## Exhibit B

### Recommended Amendments to the 2018 International Residential Code North Central Texas Council of Governments Region

**Figure R602.6.1; delete the figure and insert the following figure:**

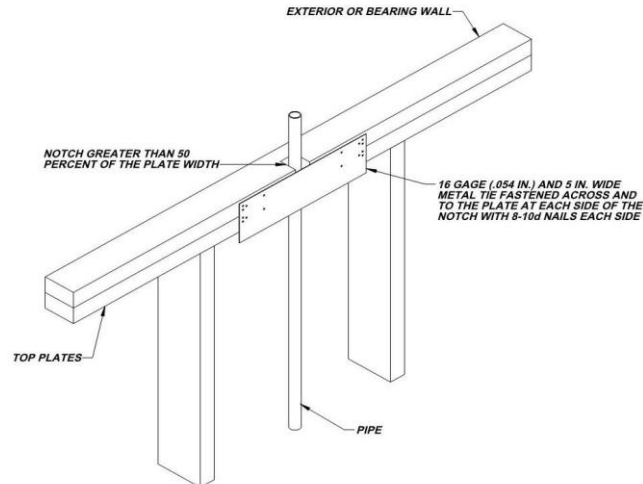
**Section R602.6.1; amend the following:**

**R602.6.1 Drilling and notching of top plate.** When piping or ductwork is placed in or partly in an exterior wall or interior load-bearing wall, necessitating cutting, drilling or notching of the top plate by more than 50 percent of its width, a galvanized metal tie not less than 0.054 inch thick (1.37 mm) (16 Ga) and -5 inches (127 mm) wide shall be fastened across and to the plate at each side of the opening with not less than eight 10d (0.148 inch diameter) having a minimum length of 1 ½ inches (38 mm) at each side or equivalent. Fasteners will be offset to prevent splitting of the top plate material. The metal tie must extend a minimum of 6 inches past the opening. See figure R602.6.1. *{remainder unchanged}*
